Instruction Sheet Number: **99TA526447**

Description: Actuator Replacement Kit

## **Instructions for Replacing the Actuator on 48ZZ401274 AND 48ZZ401282 Economizers**

Required parts: MicroMetl kit part number: KIT-ECPSTD-ACTMNT

**Figure 1 – Economizer Actuator**

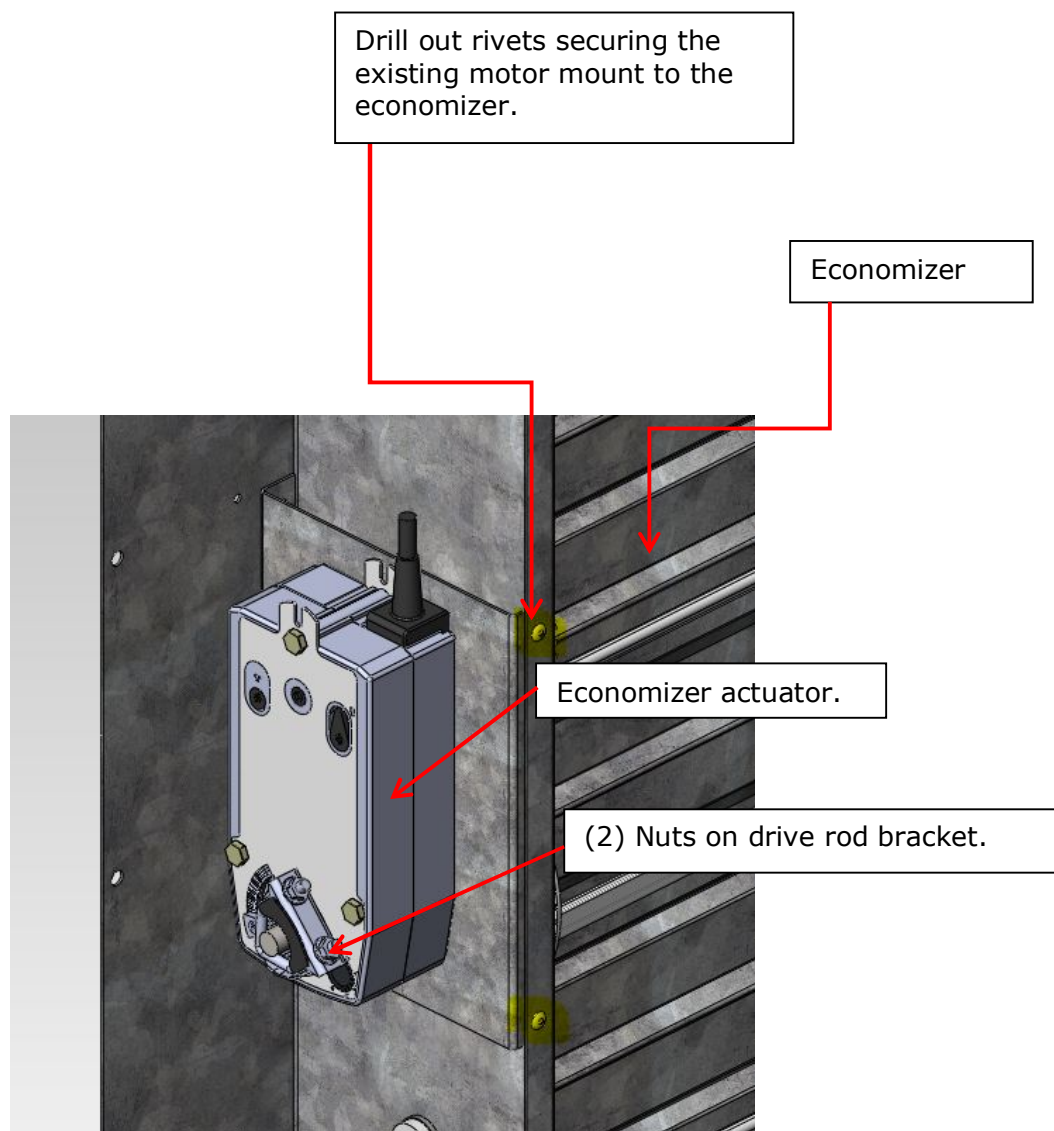
General: This kit allows the listed economizers that use the HF23BJ050 actuator, which is no longer available, to be replaced by the new HF23BJ065 actuator. Because the size of the actuators and the mounting footprints are different, a new motor mount is also required.

1. Disconnect all power to economizer and HVAC unit. Follow all local and other applicable codes.
2. Unplug the actuator from the economizer harness.
3. Remove access door and panel to gain access the economizer actuator.

4. Loosen the (2) nuts on the actuator's drive rod bracket.
5. Drill out the rivets securing the existing motor mount to the economizer frame.
6. Remove the existing motor mount, with the existing actuator attached, from the economizer.

7. Insert the new motor mount, with new actuator attached into economizer. Screw new motor mount to the economizer frame through the rivet holes.
8. With outside air damper completely closed, tighten the (2) nuts on the new actuator's drive rod bracket, locking the drive rod into place on the actuator.

9. Connect the plug on the new actuator to the economizer harness.
10. Apply power to economizer and test cycle making sure damper opens and closes completely. Adjust drive rod bracket if necessary.
